Davis-Besse Nuclear Power Station  
5501 North State Route 2  
Oak Harbor, Ohio 43449-9760

Subject: Response to Requests for Additional Information Concerning the Davis-Besse Nuclear  
Power Station Third Ten-Year Interval Inservice Inspection Program

Response to Request for Additional Information Concerning  
The Davis-Besse Nuclear Power Station Third Ten-Year Interval  
Inservice Inspection Program

FIGURE NUMBER: BO1.040.0524.1

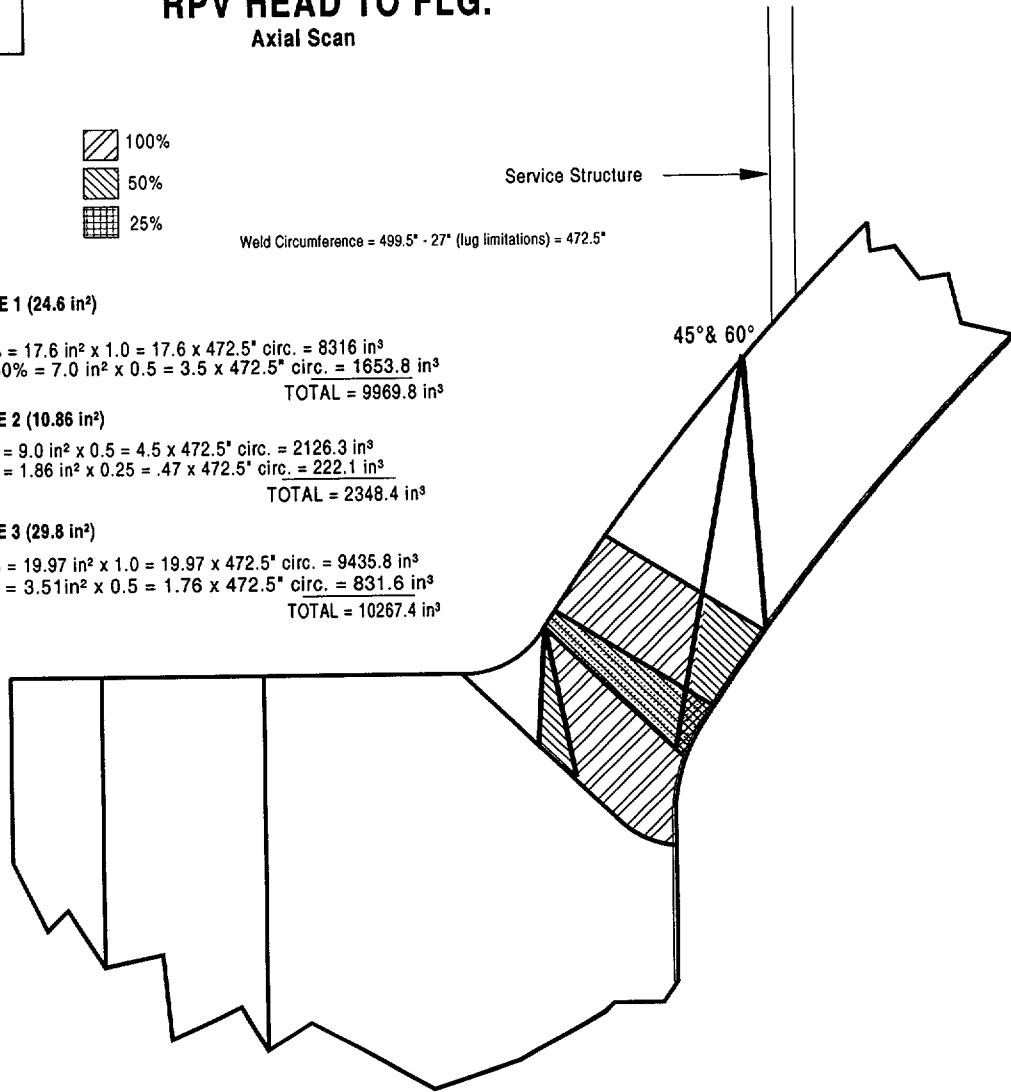
been proved to be capable of detecting flaws in the Head-to-Flange weld. In order for the proposed alternative to be acceptable, please provide the following:

- (1) The licensee has discussed design limitations that involve the transition curvature of the head base material relative to the flange and the positioning of the three lifting lugs as the main reasons for requesting relief from the Code required volumetric examination. The licensee states that because of these limitations, approximately 80% of the weld will be examined volumetrically. Provide drawings or sketches to illustrate these limitations. Also, provide drawing ISI-SK-002 which has been referenced in the basis section.

Attachment 3 shows the weld profiles and limitations associated with the Reactor Vessel Head-to-Flange Weld. Drawing ISI-SK-002 is included as Attachment 4.

100% =  $17.6 \text{ in}^2 \times 1.0 = 17.6 \times 472.5'' \text{ circ.} = 8316 \text{ in}^3$   
 50% =  $7.0 \text{ in}^2 \times 0.5 = 3.5 \times 472.5'' \text{ circ.} = 1653.8 \text{ in}^3$   
**TOTAL = 9969.8 in<sup>3</sup>**

SCALE	N.T.S.	DESIGNED	DRAWN	DATE	5-3-89
DAVIS-BESSE NUCLEAR POWER STATION UNIT NO. 1 THE TOLEDO Edison COMPANY					
DECAY HEAT COOLERS 1-1 AND 1-2 OUTLINE AND SUPPORTS					
DRAWING NO. ISI-SK-050					REV. 2

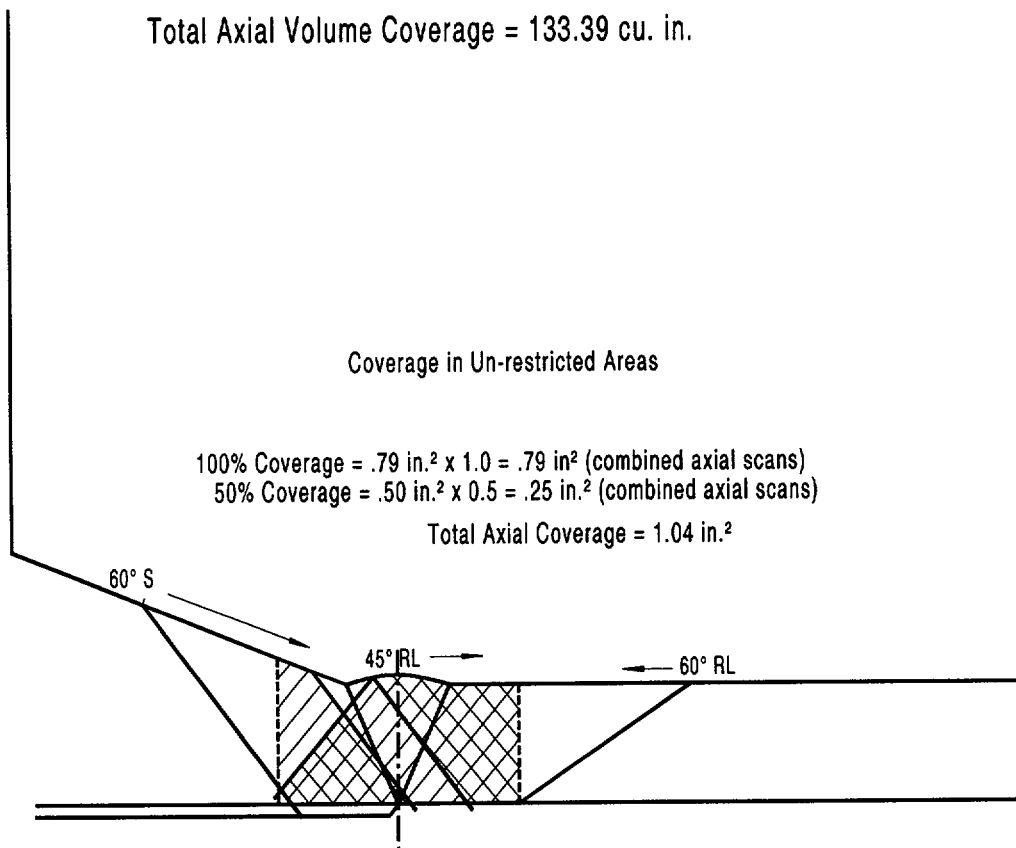
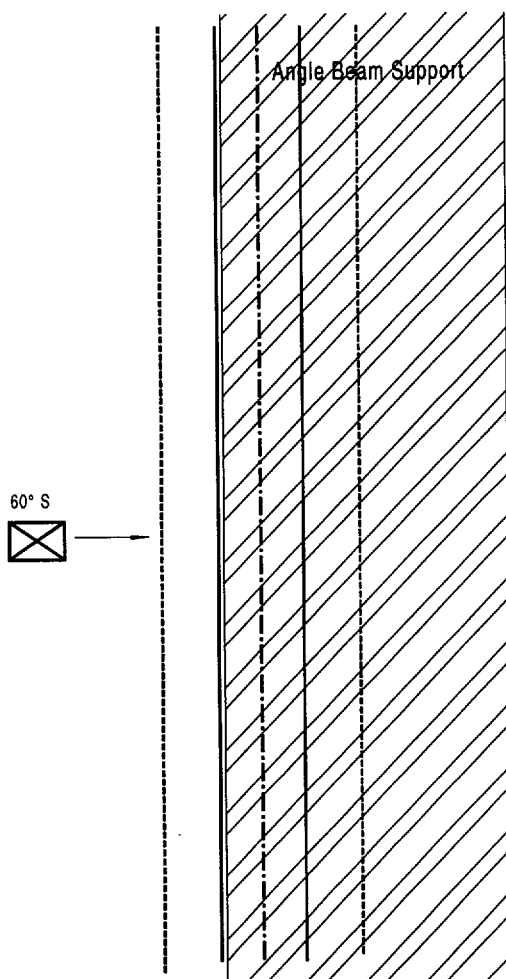
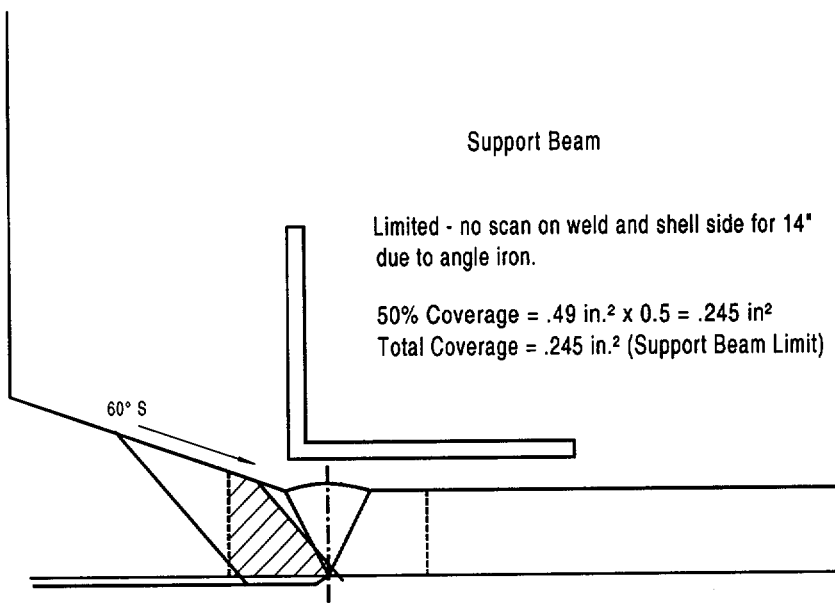
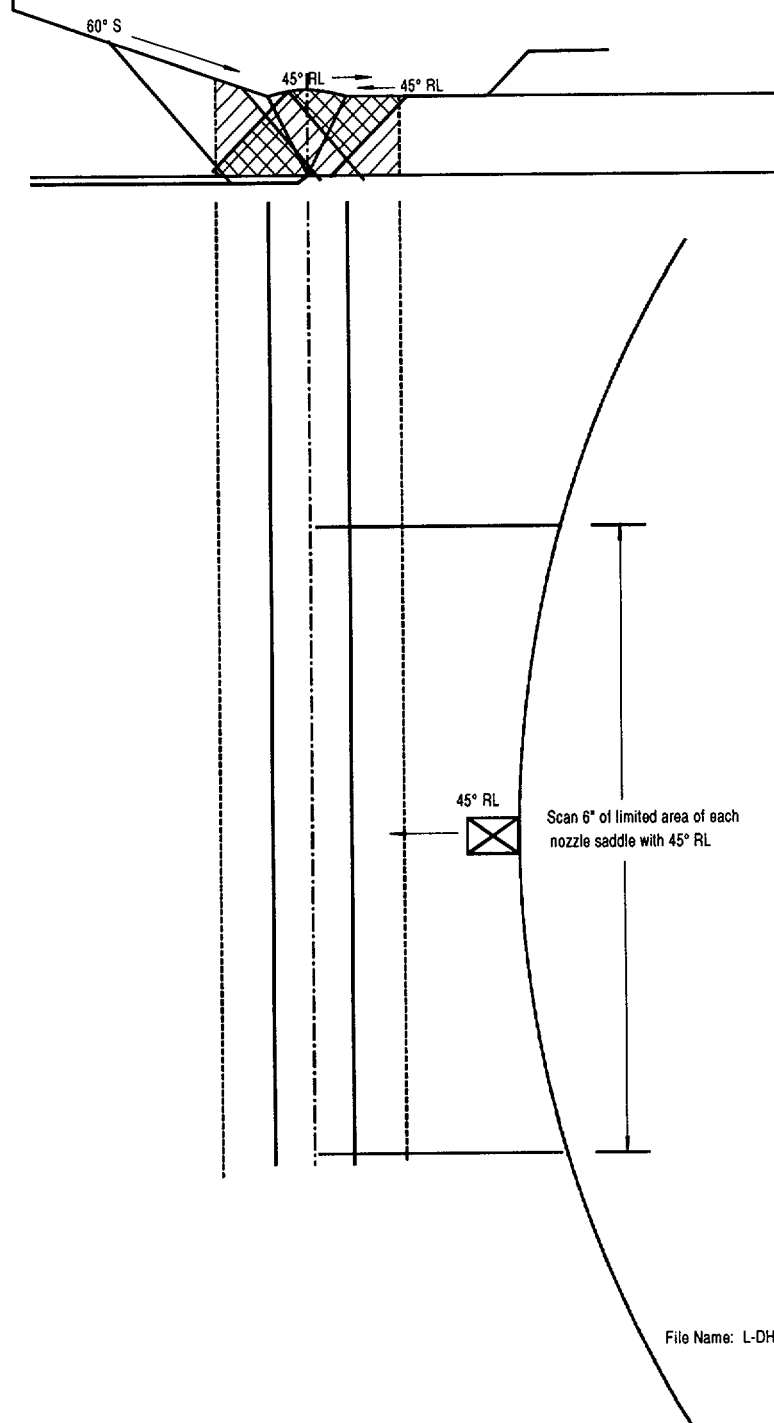
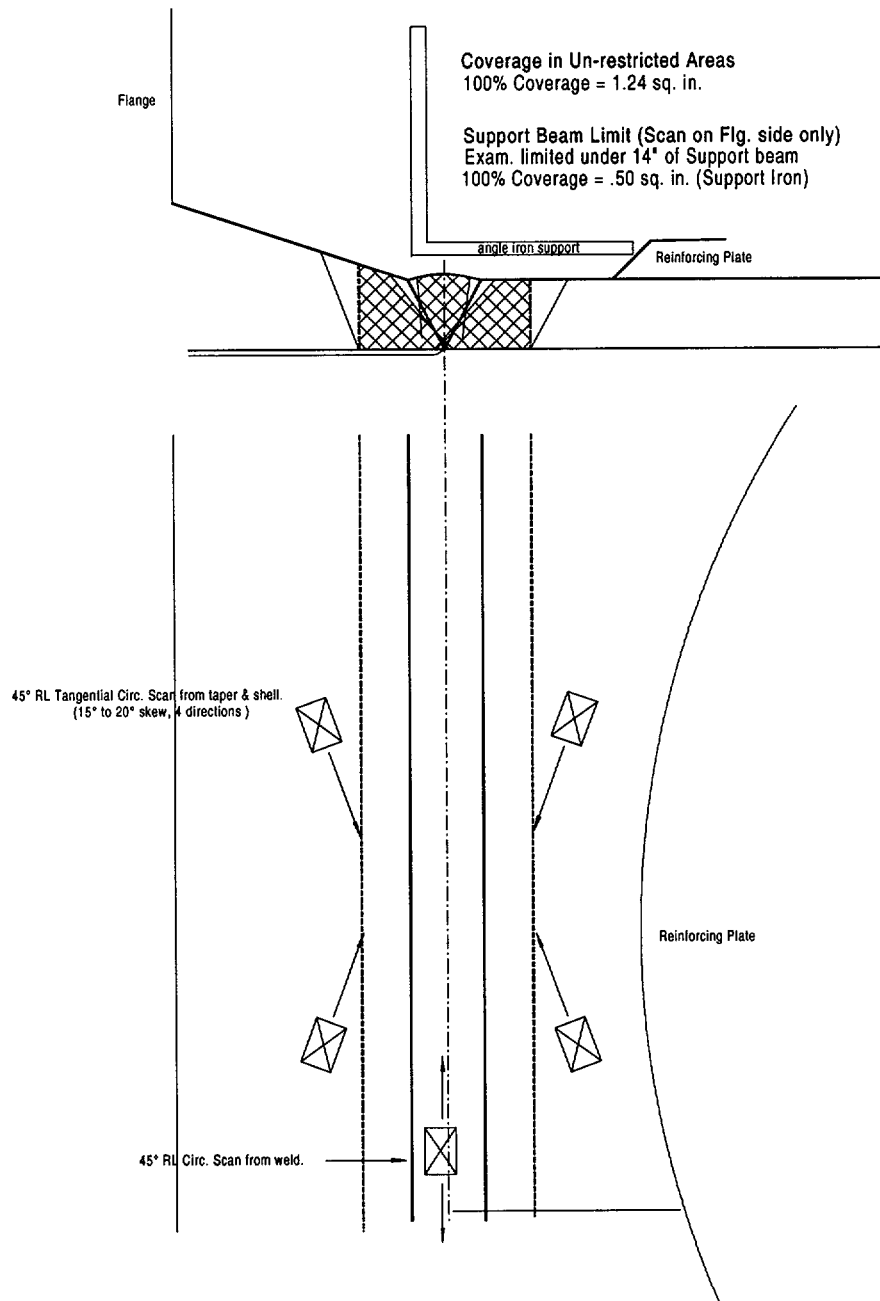
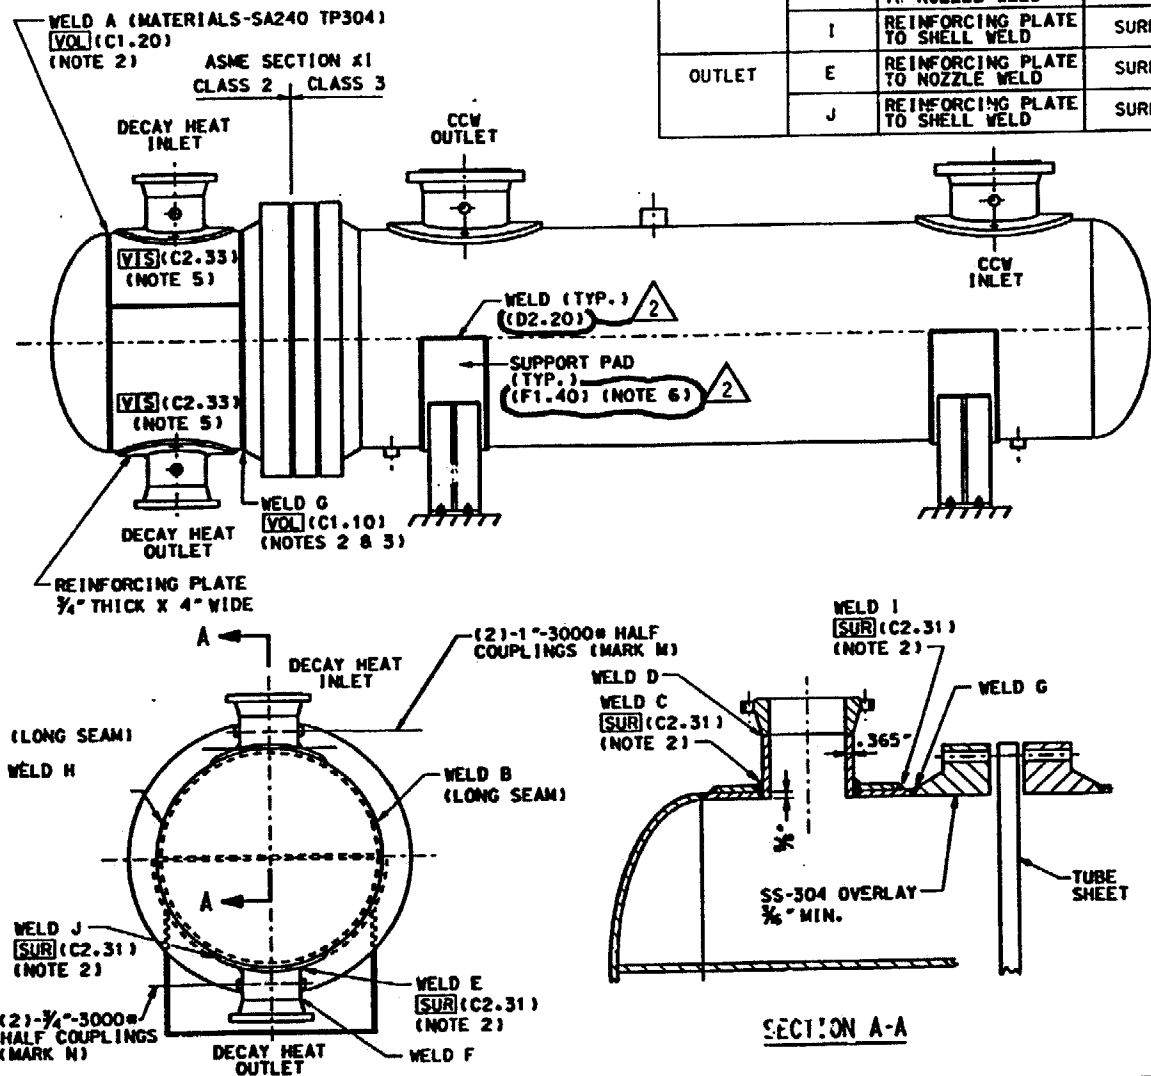
The proposed alternative examination, in conjunction with the surface examination of the reinforcing plates, has been proved to be capable of detecting flaws in the shell-to-flange welds. In order for the proposed alternative to be acceptable, please provide the following:

- (1) Illustrate with sketches and/or drawings how the specific shell-to-flange weld configurations interfere with the nearby components and limit the examination coverages.
- (2) Provide Drawing ISI-SK-050 showing the Weld G, as indicated in the Code Requirement section of the relief request.

Drawing ISI-SK-050 is included as Attachment 7.

Reinforcing Plates Limitations  
Limited area due to reinforcing plate = 12"  
(2 - 6" Areas)

Weld Circumference = 140"  
 Total Area = 1.33 sq. in.  
 Coverage under Support = 14" x .5 sq. in. = 7 cu. in.  
 Coverage of remaining weld = 126" x 1.24 = 156 cu. in.  
 Total Circ. Coverage = 163 cu. in. (unrestricted + limited areas)

SCALE N.T.S.	DESIGNED	DRAWN WME	DATE 5-3-89
DAVIS-BESSE NUCLEAR POWER STATION UNIT NO. 1 THE TOLEDO EDISON COMPANY			
REACTOR VESSEL INLET AND OUTLET NOZZLE DETAILS CONTAINMENT BUILDING			
DRAWING NO. ISI-SK-003			REV. 2

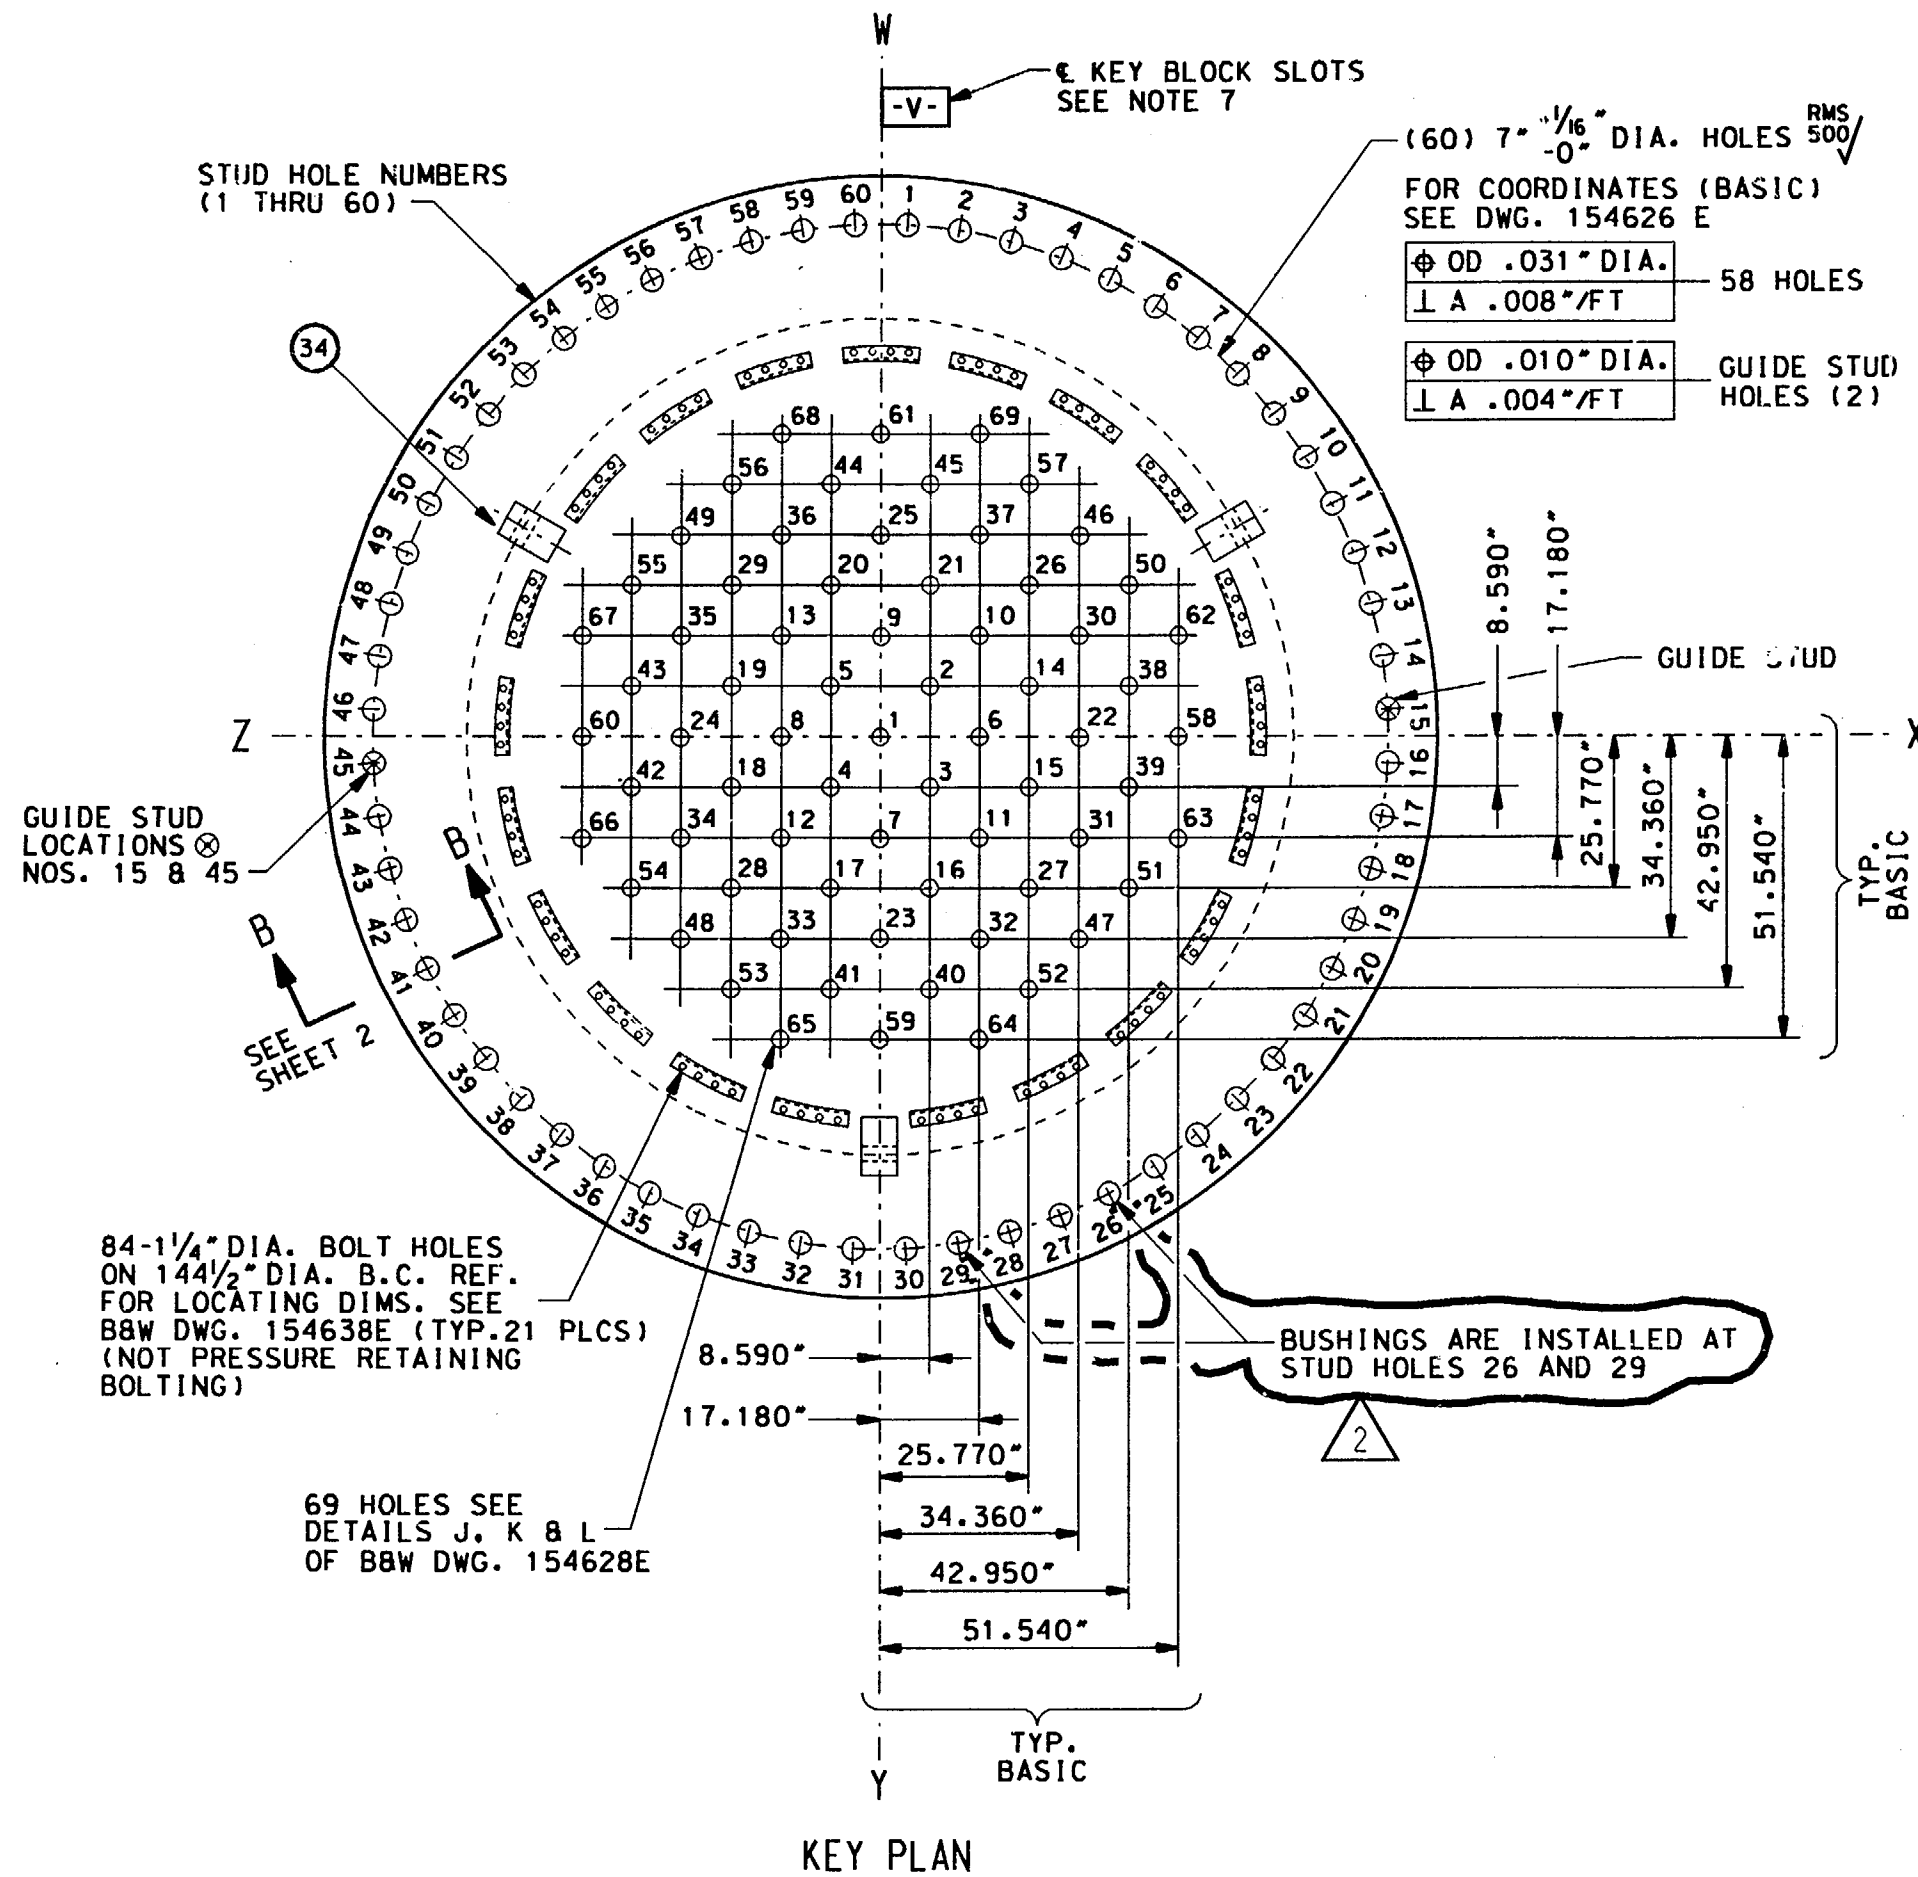
- RAI 2.1 Request for Relief No. RR-A1 – Pursuant to 10 CFR 50.55(a)(3)(i), the licensee requested the required surface examination for the reactor vessel inlet and outlet nozzles to pipe welds and the reactor vessel nozzle to core flood safe end welds be replace[d] with an ultrasonic examination from the ID which is capable of detecting opposite side surface flaws.

The proposed alternative examination has been proven capable of detecting flaws originating from the outside surface of the piping. The license states that Performance Demonstration Initiative (PDI) will include the examination of piping from the inside surface as part of the qualification process for Supplement 12 of Appendix VIII. In order for the proposed alternative to be acceptable, please provide the following:

1. THE WELD IDENTIFICATION NUMBERS ARE PRECEDED BY "RPV-"
2. WELDS WR-53-Y AND WR-53-W DO NOT REQUIRE A SURFACE EXAMINATION. SEE RELIEF REQUEST RR-A1.
